Independent School District #146
Buildings and Grounds Committee Meeting
9:00 AM on July 28, 2020
Barnesville High School
302 3rd Street South
Barnesville, MN 56379

FIELD CHANGE ORDER #11

TITLE: *Plumbing Review Revisions*

PROJECT: *Barnesville Public Schools
Additions and Remodeling*

A-1650

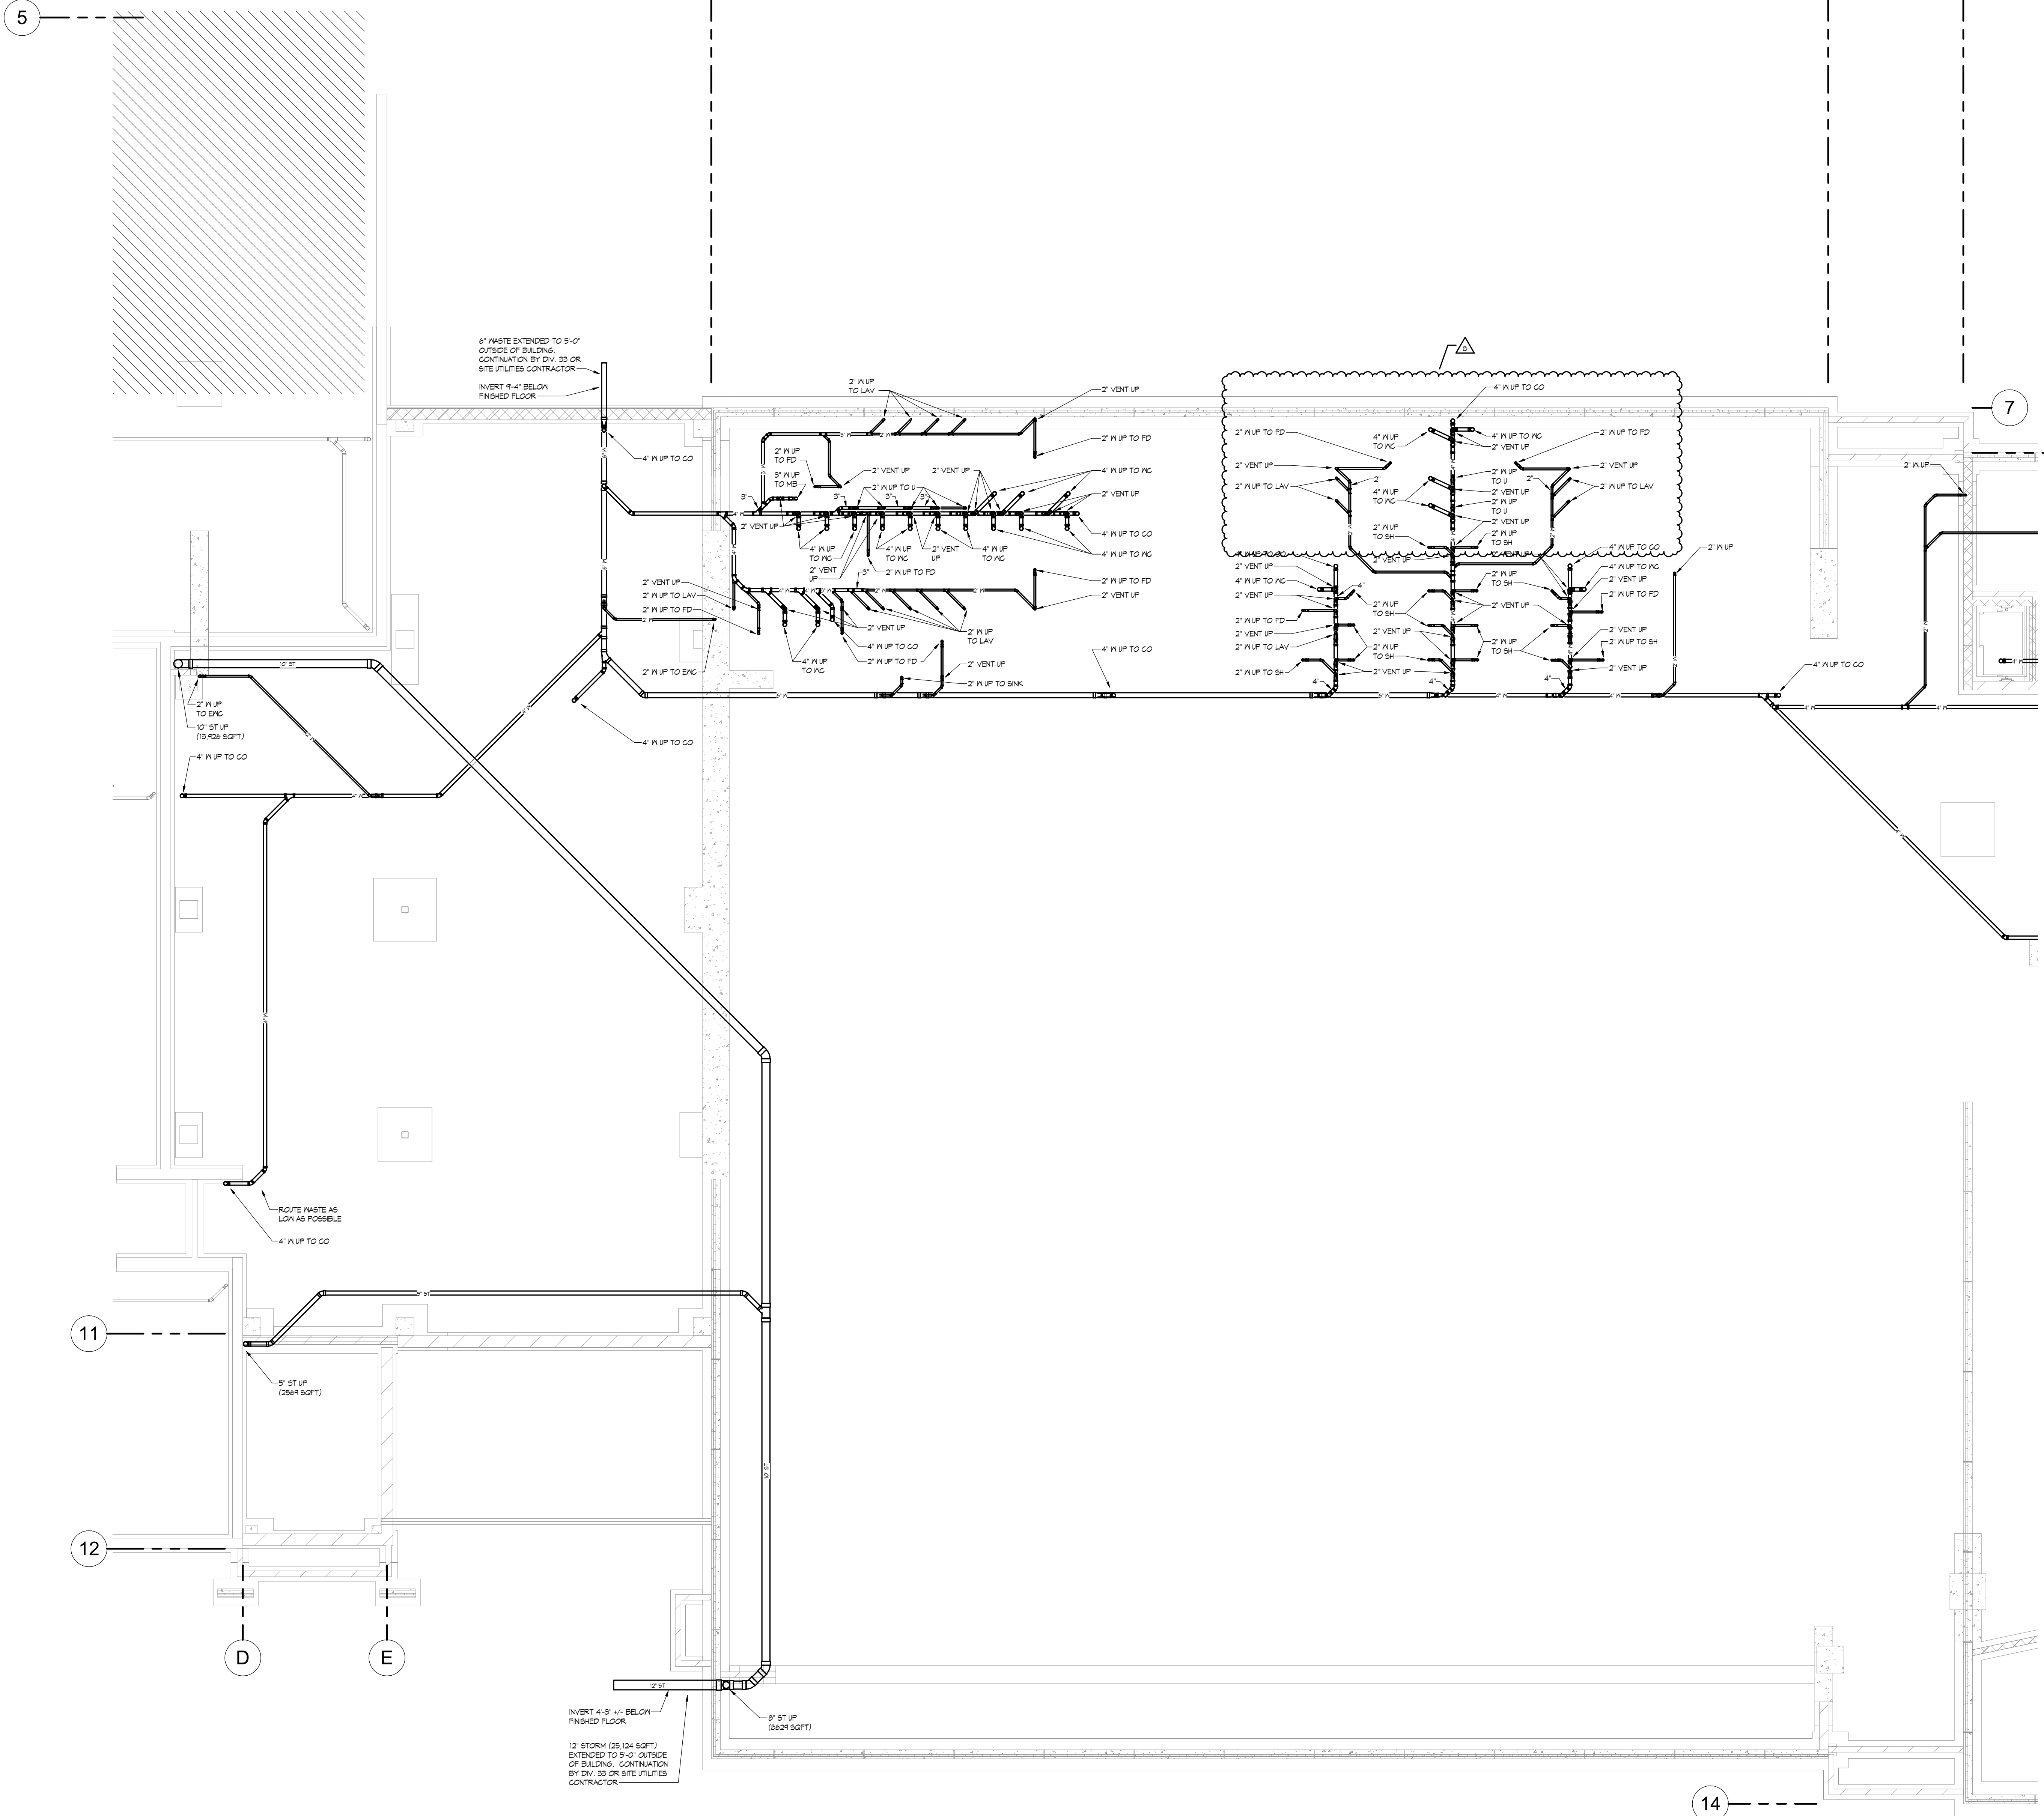
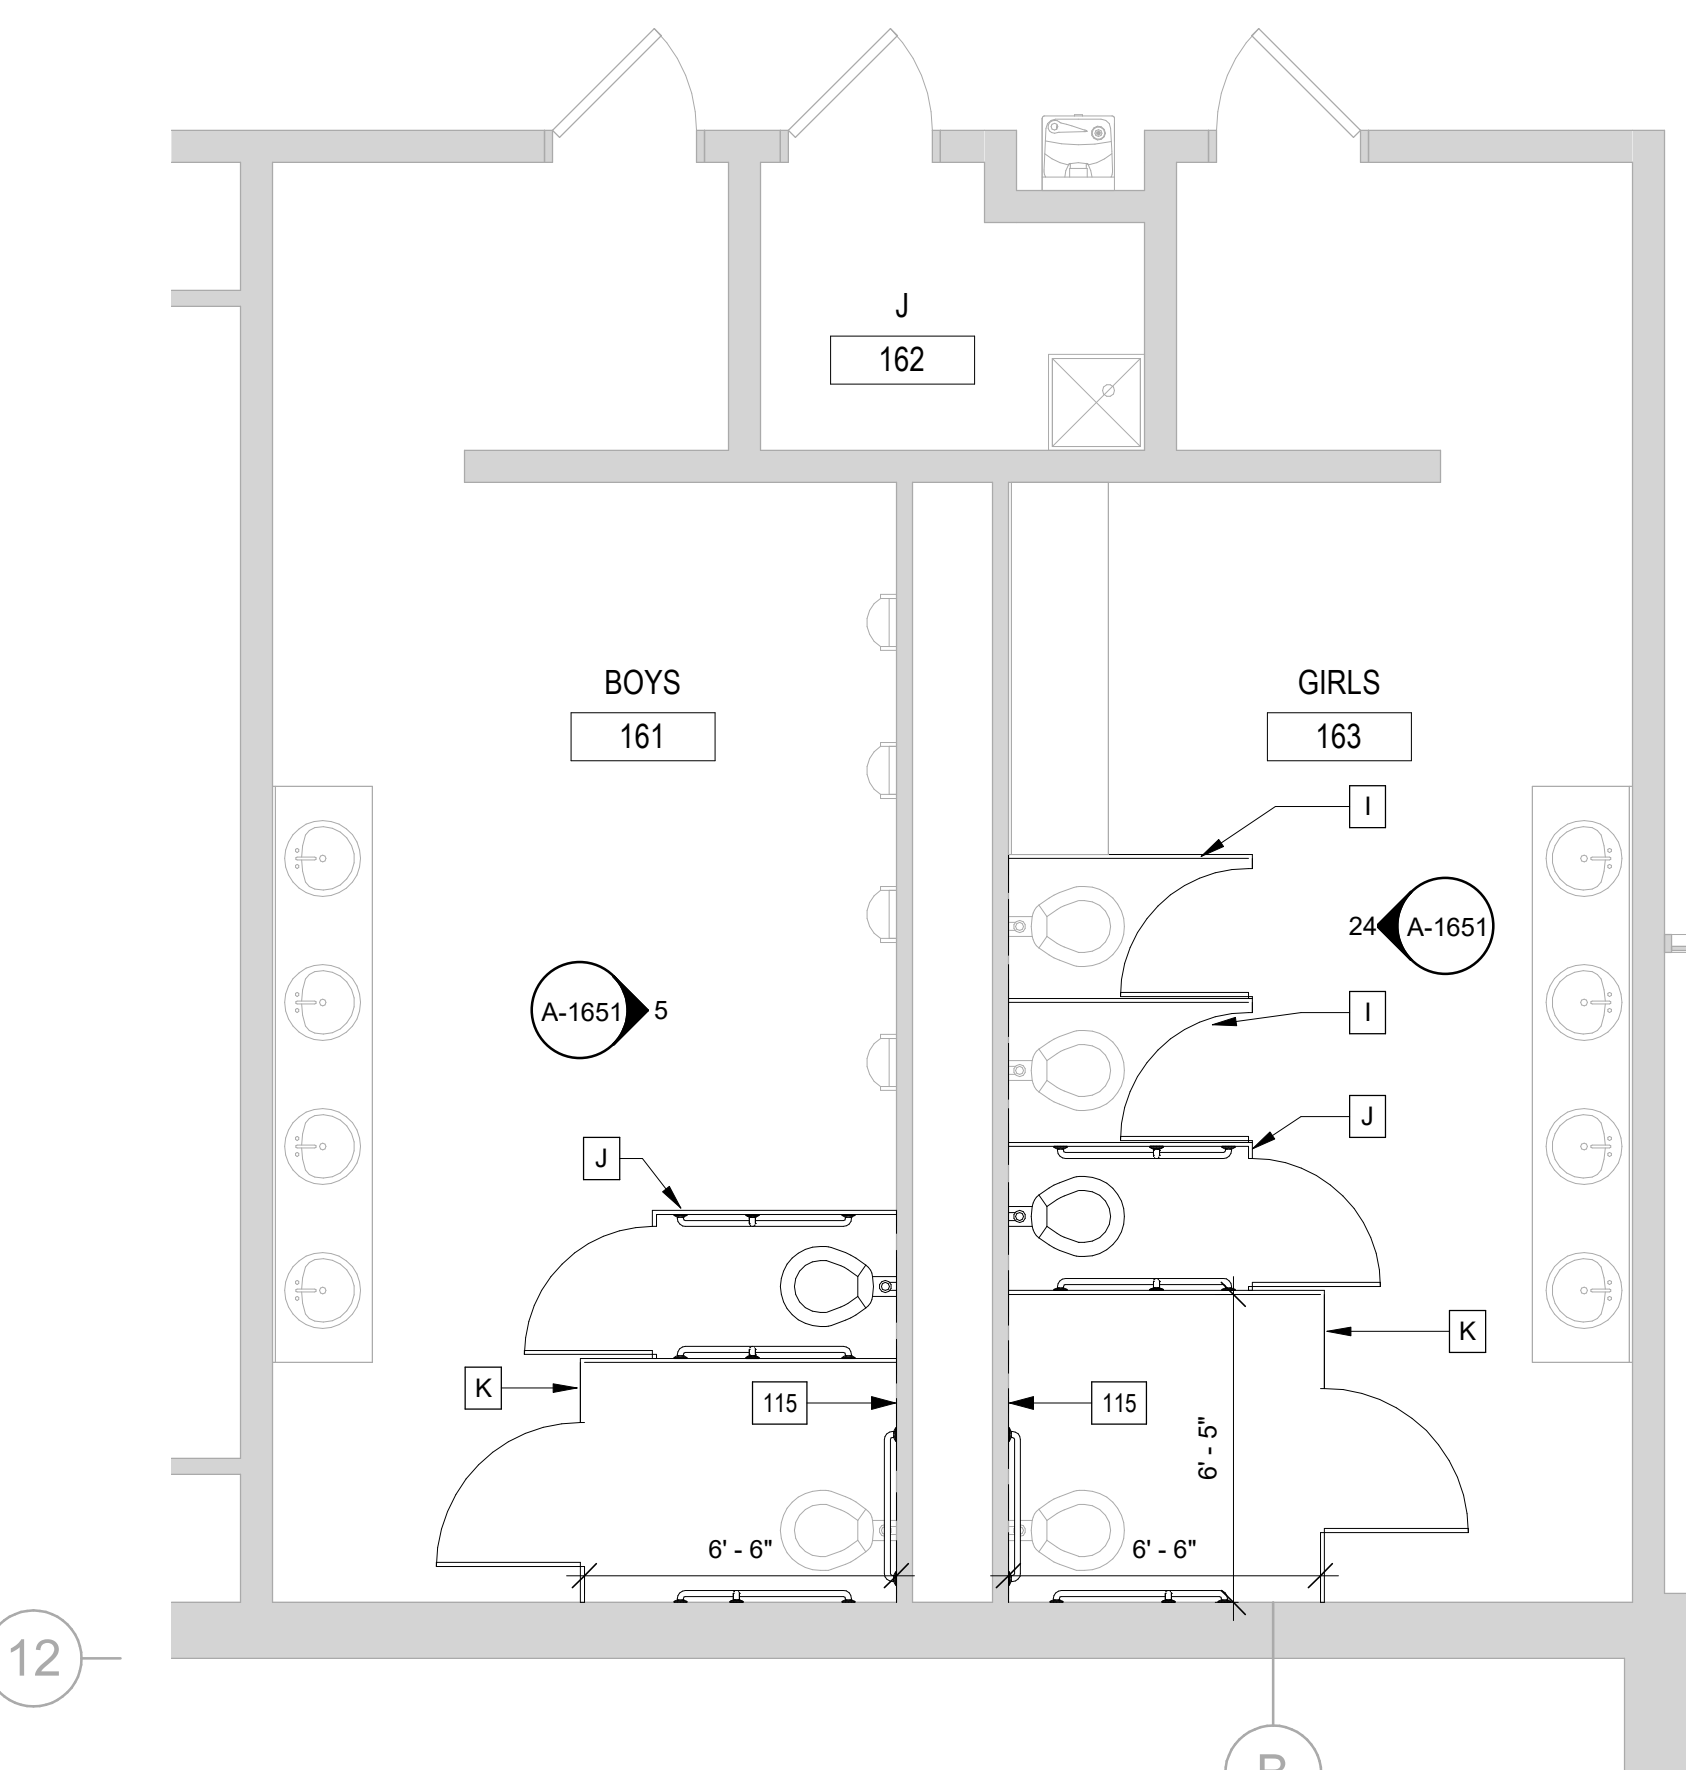
- I. Refer to the attached sketches dated 06/19/2020.
 - 1. At 176B and 177B, provide core fill in masonry walls as indicated.

- 1. Refer to Sheet A-1650 – HS – Enlarged Toilet Plans
 - A. Revise plumbing fixtures and bath accessories as indicated. Refer to Mech.
 - B. At 176B and 177B revise masonry wall type to be M8 at shower wall.

M-1204

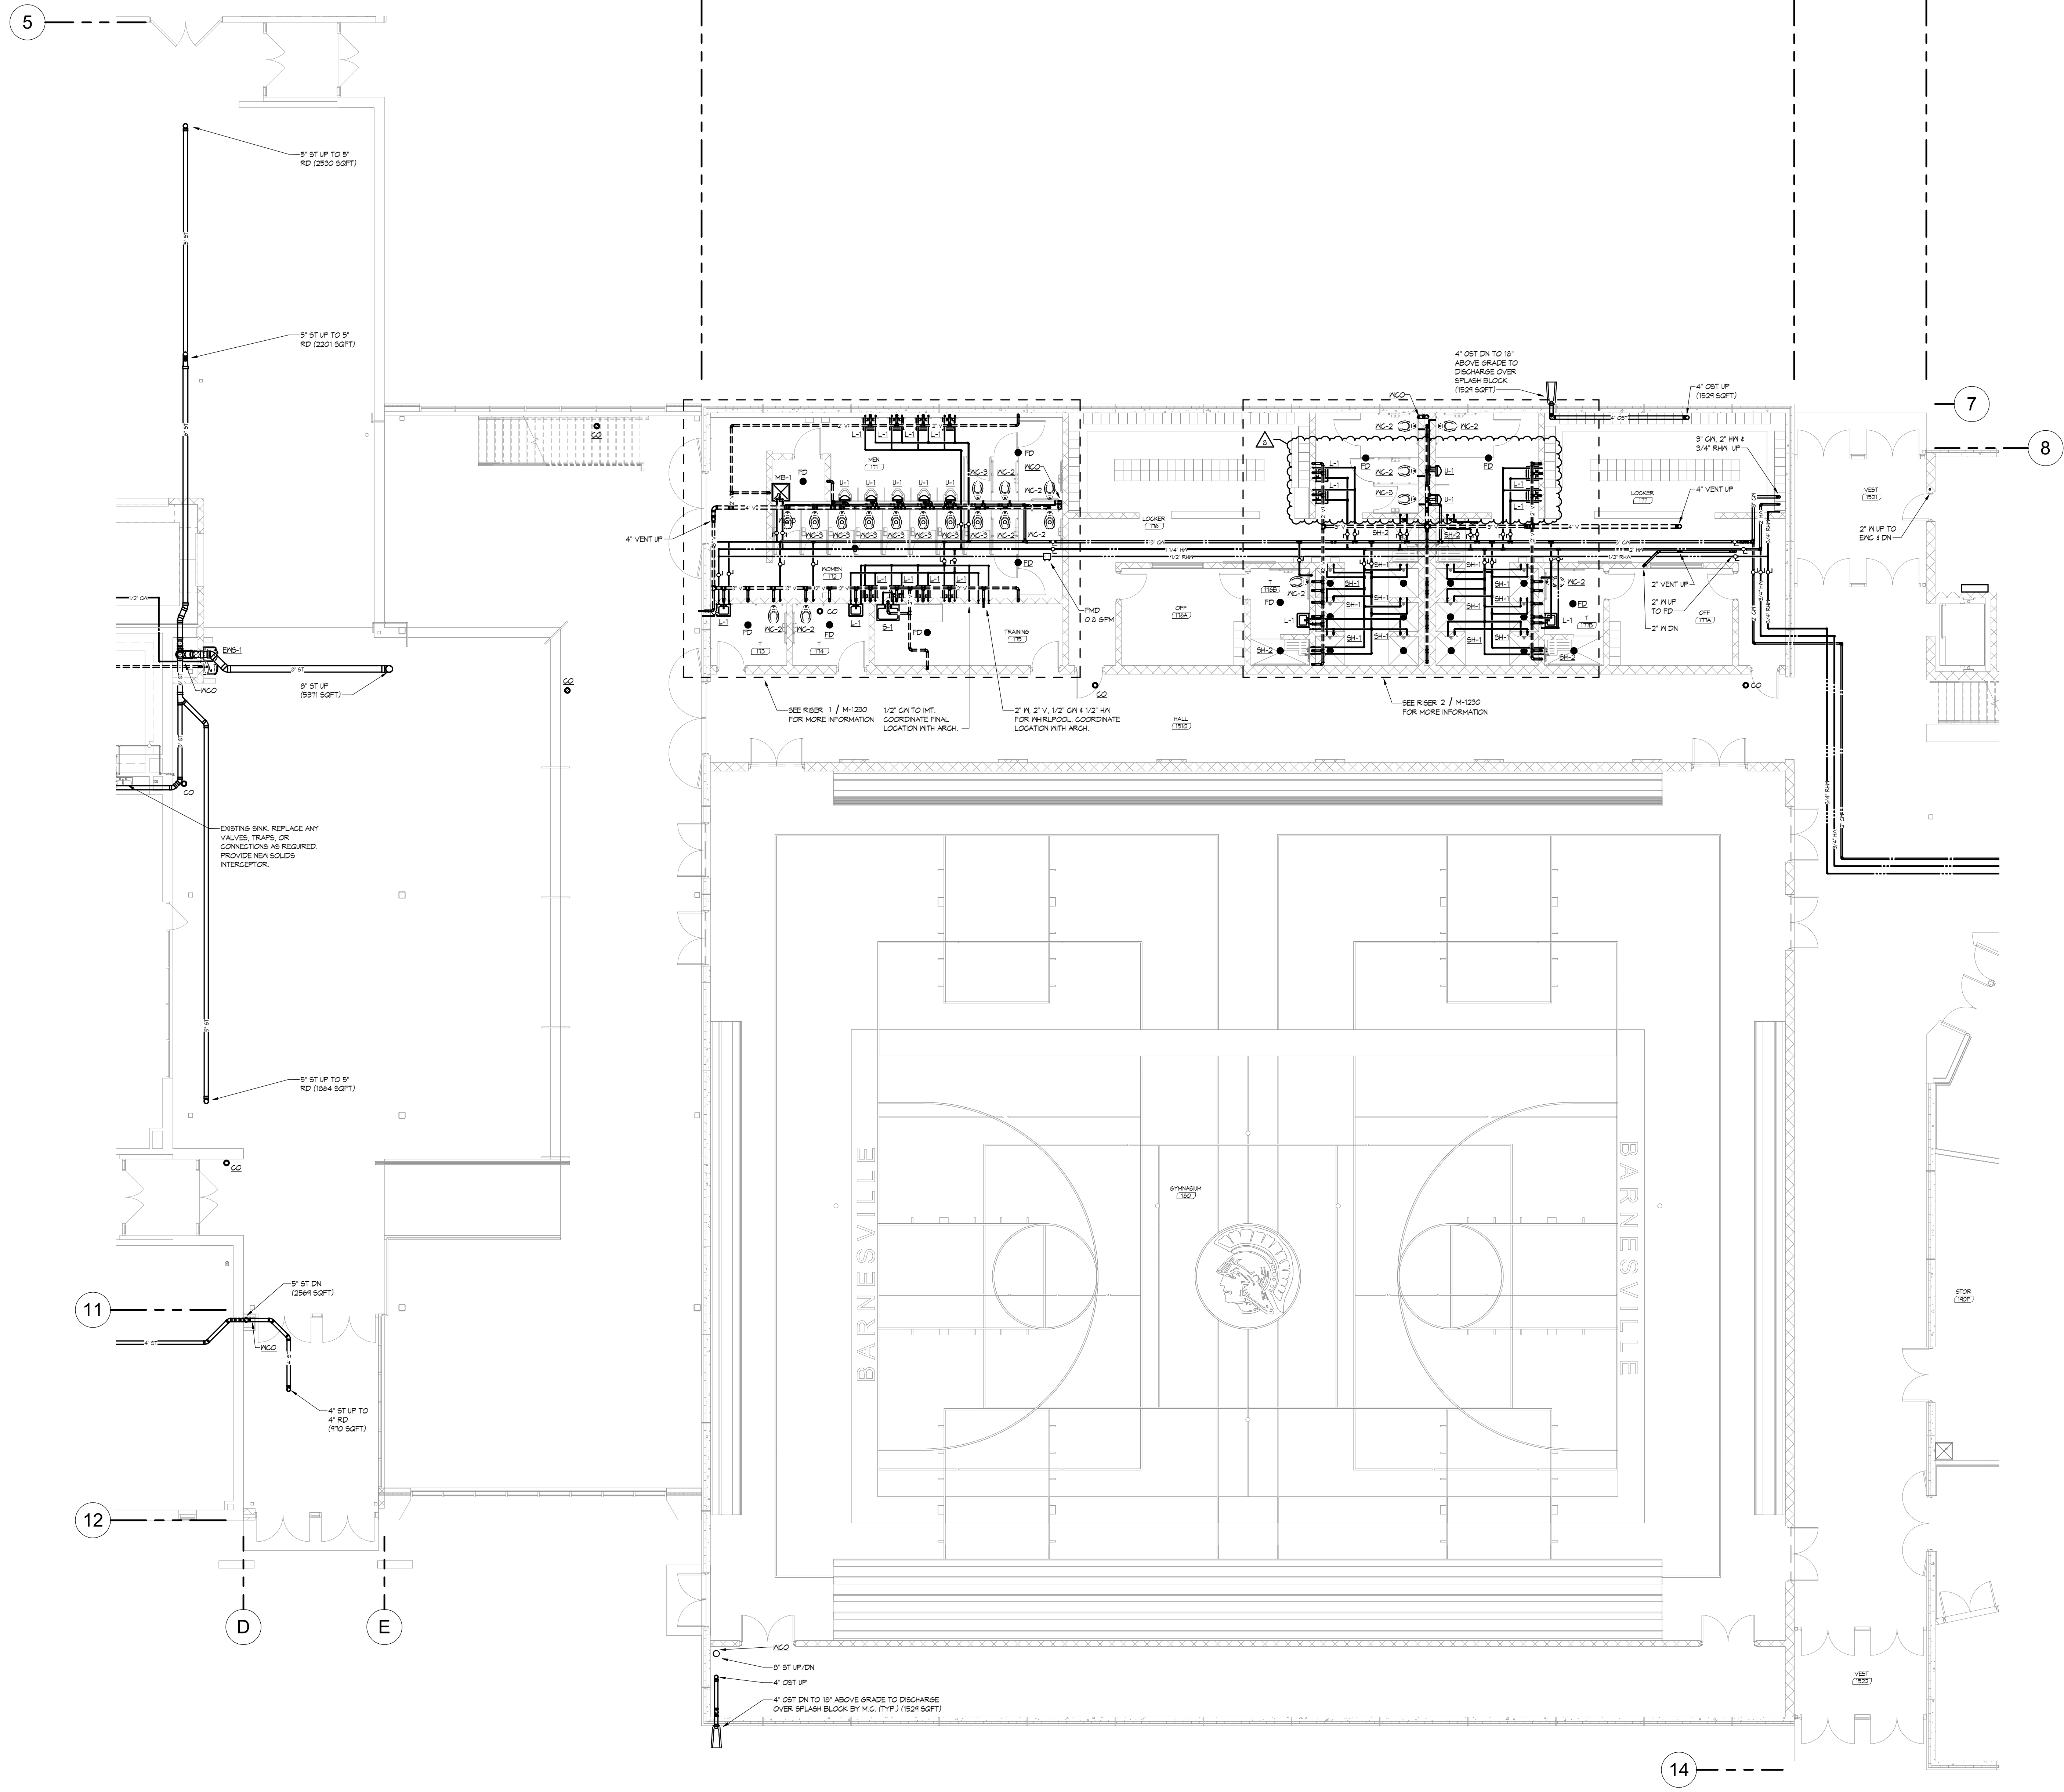
See attached for updated locker room layouts. Urinals were added, and lavatories were removed.
